Weldment Assembly Repair

<h1 style="margin: 0;">SIKORSKY</h1> <h1 style="margin: 0;">AIRCRAFT</h1> <h1 style="margin: 0;">DESIGN RECORD BOOK</h1>			
Prepared by: <u>Kenny Welch</u>		DRB No: <u>2017-SA-92-090</u>	
Title: <u>Weldment Assembly Repair</u>			
Start Date: <u>6/21/2017</u>		Detail Dwg: <u>92306-04102</u>	
End Date: _____		Assy Dwg: <u>92306-04102-057</u>	
No. Pages: _____		Related Documents: (1) _____ (3) _____	
Model: <u>S-92A</u>		(2) _____ (4) _____	
Keyword: (1) <u>Crack</u> (2) <u>Weldment</u>		Hours: _____

## Background

**Figure 1- Reported Damage**

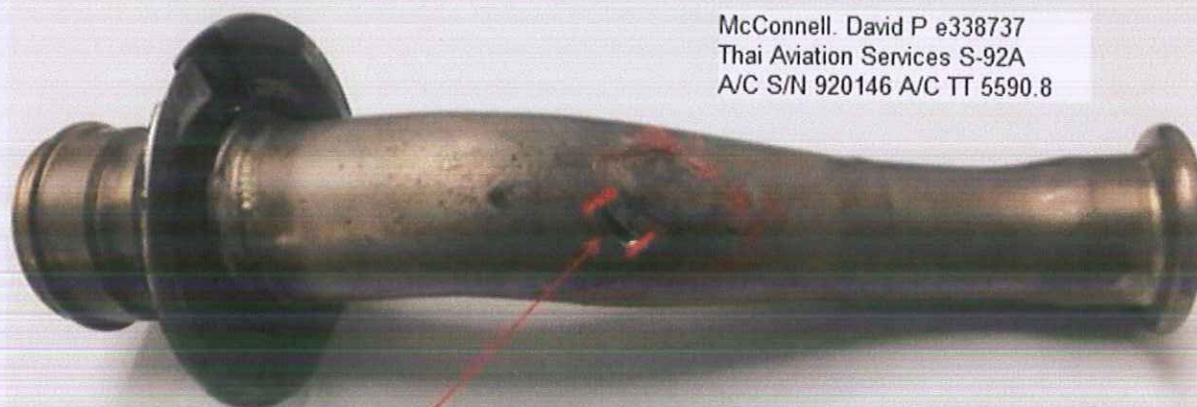
The No. 1 engine weldment assembly P/N 92306-04102-057 was found chafed by the No. 1 engine inboard expandable pin due to pin migration.

The chafed opening measures 0.625 in. long x 0.125 in. wide, and is located approximately mid-span on the tube.

Total Length 0.625"  
Width 0.125"

1. Remove the Weldment Assembly from the aircraft.
2. Repair the chafe damage by welding per MIL-STD-2219 Class B using AMS 4951 filler wire. Grind flush.  
Note: Do not cut the damaged area out - just apply a weld bead (puddle) into the chafe.
3. After welding, stress relieve per AMS-H-81200 AT 850 +/-25F FOR 2 +/- 0.25 hours.
4. Penetrant inspect ASTM-1417, no cracks allowed.
5. Upon completion of repair the unit will be pressure tested to 120 PSIG for 5 minutes. Zero leakage is allowed.
6. If any problems are encountered or if further assistance is required, please contact Service Engineering.
